PUBLIC HEARING MEMORANDUM

SUBJECT: **Petition #504-22**, for SPECIAL PERMIT/SITE PLAN APPROVAL to raze the existing single-story dwelling at 15 Algonquin Rd and construct five single-family attached dwellings with reduced setbacks, which exceeds the maximum lot coverage, a retaining wall greater than 4 feet in height within a setback and to allow parking dimensional relief at 71 Commonwealth Ave, Newton, Ward 7, on land known as Section 63 Block 01 Lots 13 and 13A, containing approximately 32,980 sq. ft. of land in a district zoned MULTI RESIDENCE 1. Ref: 7.3.3, 7.4, 3.4.1, 3.2.4, 6.2.3.B.1, 5.1.8.B.6, 5.1.13, 5.1.8.D.1, 6.2.3.B.2, 5.4.2 of Chapter 30 of the City of Newton Rev Zoning Ord, 2017.

ZONING REVIEW MEMORANDUM

RE: Request to allow six single-family attached dwellings

Proposed Site Plan

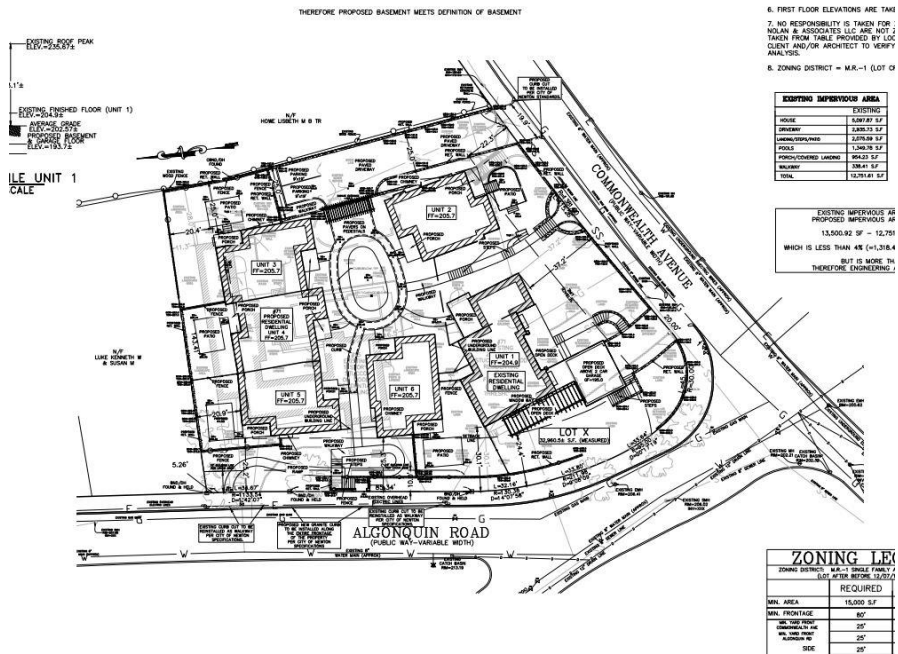
Three townhouse style units (Units 3, 4, and 5) are proposed parallel to the north lot line. The remaining two units are standalone structures, with one unit fronting Algonquin Road (Unit 6) and the other fronting Commonwealth Avenue (Unit 2). As proposed Unit 2 will have a front setback of 22.3 feet from its front porch to Commonwealth Avenue and the northeast corner of Unit 3 will have a rear setback of 20.4 feet, both requiring a special permit. Aside from 71 Commonwealth Avenue (Unit 1), the new construction along Algonquin Road meets the required 25-foot front setback.

Landscaping is proposed along the frontages on Algonquin Road and Commonwealth Avenue, and courtyard lawn space is proposed, with pathways providing access from the rear of each unit. The project proposes 28.4% lot coverage where 25% is the maximum, which requires special permit relief. The open space proposed is 58.9%, where 50% is the minimum required, and requires no relief. Several retaining walls are proposed that do not require relief. However, the retaining walls within the front setback from Algonquin Road reach a maximum height of 4.9 feet. A special permit is required for a retaining wall that is four feet tall or higher located within a setback. Planning Staff notes that the existing retaining wall along the frontage of Commonwealth Ave appears to be over four feet, however the measurement is not provided.

The Planning Department encourages the Petitioner to revisit the lot coverage prescribed for single family attached dwellings and whether the proposed lot coverage of 28.4% can be brought closer into compliance with the 25% set forth in the Ordinance.
